**2. An Important Finding of the NAS Committee is that LANL/DOE have Failed to Install a Reliable Network of Monitoring Wells in the Regional Aquifer.**

The new network of LANL R-wells that were installed in the regional aquifer during the past ten years as an activity of the LANL Hydrogeologic Workplan Project is displayed on Figure 2-1. Below are excerpts from the prepublication copy concerning the NAS committee's general findings on monitoring and data quality:

Figure ES-1. Number of categories of residual drilling effects present in the most recent sample from each screen (as of December 31, 2006)

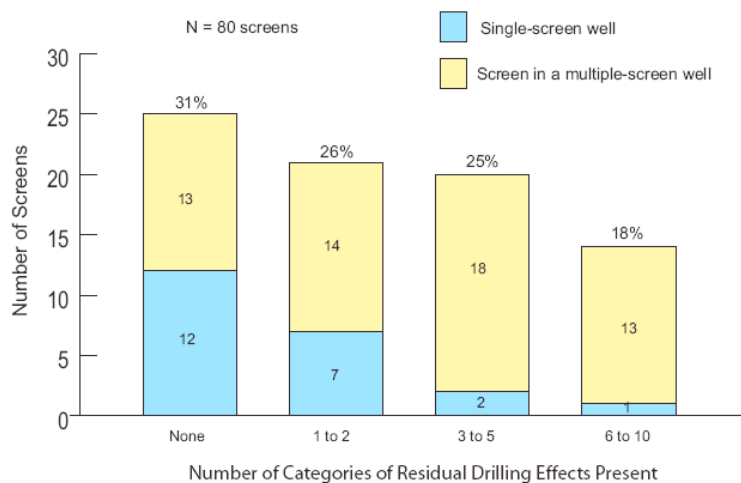
The above figure shows that 58 of the 80-screened intervals are in multiple-screen wells. The figure shows that an inherent problem with the assessment results in the WSAR-2 is that water samples are produced from 56 – *i.e.*, 70% of the screened intervals with no-purge sampling methods. Both the NAS committee and the staff of the New Mexico Environment Department describe the poor reliability of water samples collected with no-purge methods. Below is an excerpt from the NAS prepublication copy about the poor quality of the no-purge water samples:
